# UNITED STATES PATENT AND TRADEMARK OFFICE

APPLICATION NO.	FILING DATE	FIRST NAMED INVENTOR	ATTORNEY DOCKET NO.	CONFIRMATION NO.
10/765,958	01/29/2004	Hiroshi Takeuchi	MIT-024-USA-P	2329

**Office Action Summary**

### **DETAILED ACTION**

Figure A

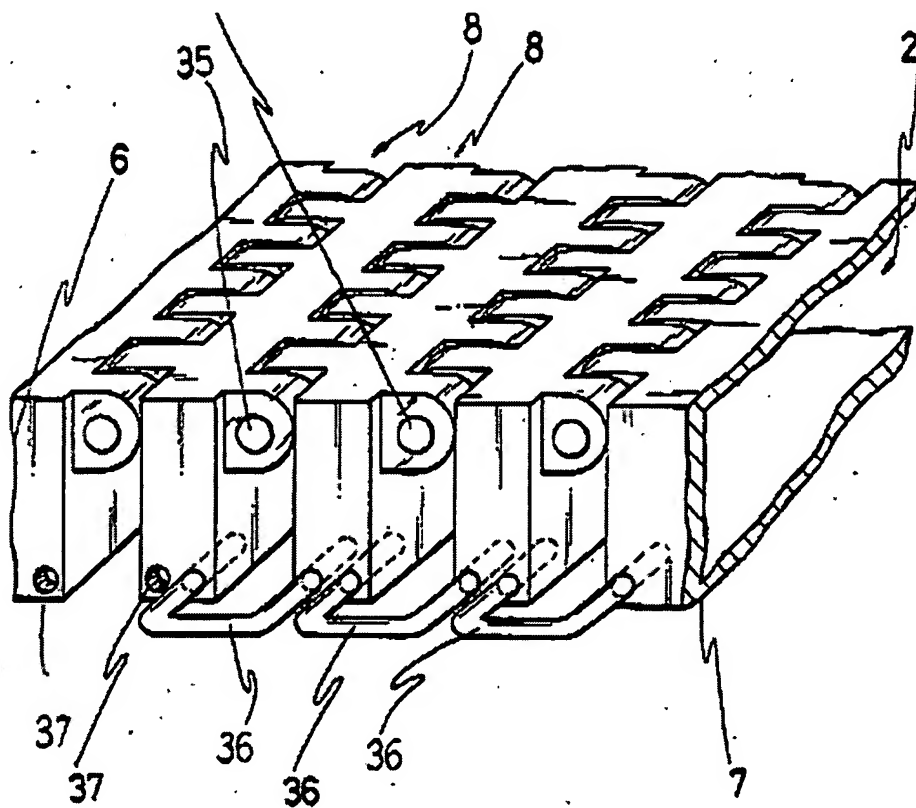
FIGURE A better shows the cited structures of TORAN and is depicted below. While TORAN

discloses side by side bars 8, they fail to show the ability to be shortened and extended; while

TORAN discloses disengagement preventing means 35, they fail to show disengagement

preventing means comprising hooks formed at a tip of some of the connecting protrusions; while

TORAN discloses corresponding accepting recesses, they fail to show corresponding accepting

recesses having steps therein adapted to engage the hooks, so that the hooks and steps are

engaged with each other when the respective adjacent bars are kept furthest away from each

other; as recited in the claims. SHIRAI teaches a bottom structure of a bed similar to that of

As to claim 3, TORAN discloses first beveled portions are formed on lower sides at the tips of the connecting protrusions while second beveled portions are formed on the upper sides at the bases of protrusions, to use the bendable bottom member as a bendable portion between the back region and the waist region. See FIGURE A above.

As to claim 4, TORAN discloses first beveled portions are formed on the upper sides at tips of connecting protrusions, while second beveled portions are formed on lower sides at the bases of protrusions, to use the bendable bottom member as a bendable portion between the waist region and the leg region. See FIGURE A above, but reverse the labels of first and second beveled portions. Claims 3 and 4 are not interdependent and so the alternative interpretations are valid.

As to claim 5, TORAN discloses the second beveled portions at the bases of the connecting protrusions are inclined in adaptation to the desired bending angles with the adjacent bars. See FIGURE A above.
